A. ADMINISTRATIVE REPORT & DECISION

Project Name: Weston Heights North Short Plat

File Number: LUA16-000140

Project Summary: The applicant is requesting Preliminary Short Plat approval, a Modification to the street standards (RMC 4-6-060) for a reduction in the required right-of-way dedication width, and Environmental (SEPA) Review for the subdivision of an existing 107,639 square foot (2.47 acre) site zoned Residential-4 (R-4) into 6 lots for the future construction of single family residences. The applicant is proposing to utilize the small lot cluster provisions, which would allow them to utilize the R-6 development standards in exchange for setting aside 20 percent of the site as open space with a soft surface public trail. The proposed lots would range in area from 7,173 square feet to 32,018 square feet. An existing residence and detached outbuilding are proposed to remain on Lot 1. The proposed short plat would also result in the creation of 3 tracts (Tracts A, B, and C) and a Private Road C. The Private Road is proposed to provide access to the abutting Weston Heights Plat (LUA14-000958) to the south of the project site. Access to the new lots is proposed via residential

EXHIBIT 11

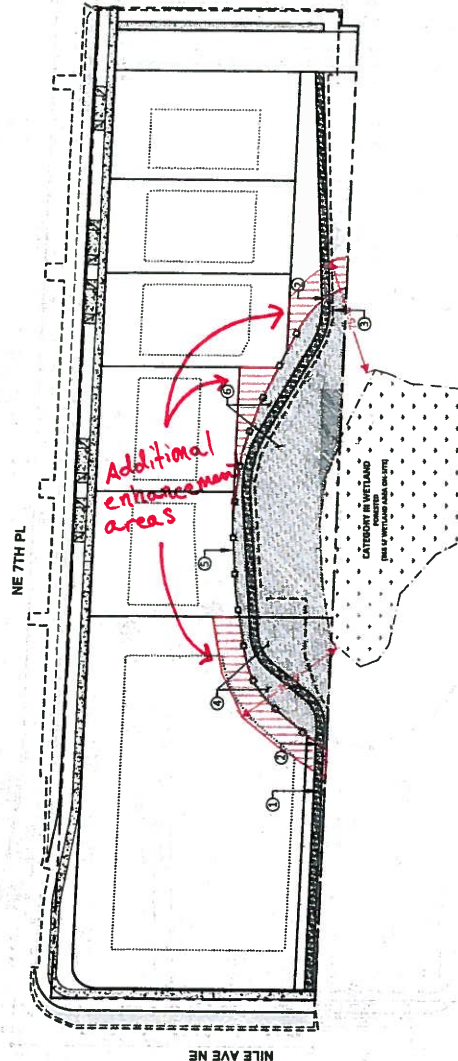
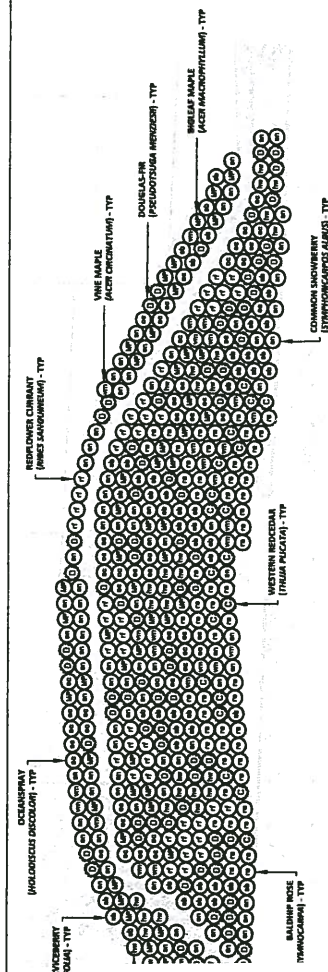
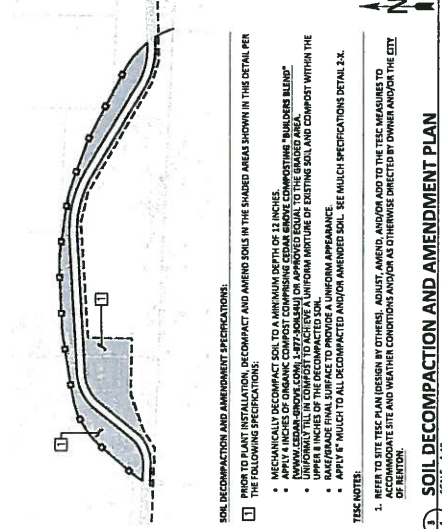
4. The proposed Critical Area Mitigation Plan shall be amended to provide additional enhance wetland buffer areas as depicted in Exhibit 11. A Final Critical Area Mitigation Plan shall be submitted at the time of Utility Construction Permit review for review and approval by the Current Planning Project Manager.
